RUAPEHU DISTRICT COUNCIL

RESOURCE CONSENT APPLICATION NO. 107258, 107259 and 107260 RANGATAUA WWTP

Table 1: Response to s.92 request for further information

Table 1: Response to s.92 Request for Further Information

Figure 4: Cross-sectional view of surface flow wetland design (Sourced from Tanner et al 2010³)

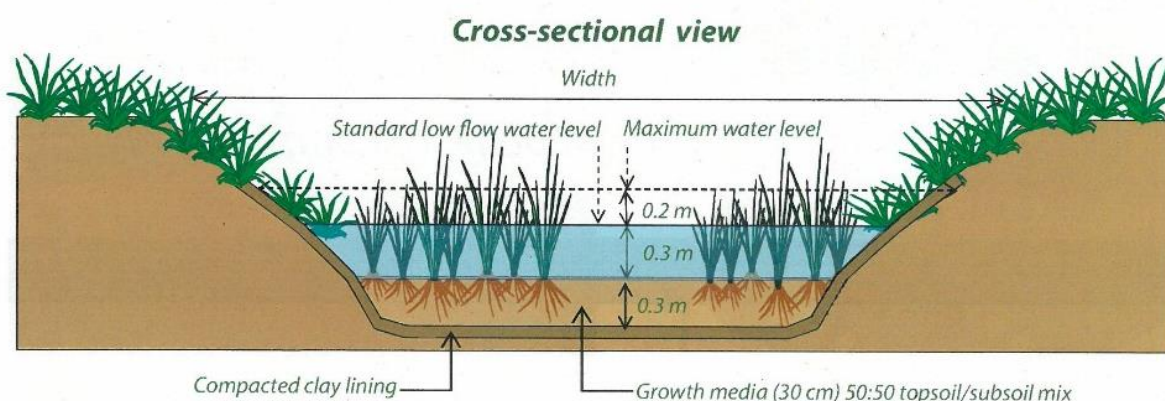
The upper portions of the wetland area (i.e. those sections above the current inlet pipe) will also require some earthworks to create a more flat bottomed, 5m wide profile to the existing channel (as shown in Figure 4). The amount of earthworks required to improve the form of this section is minor.
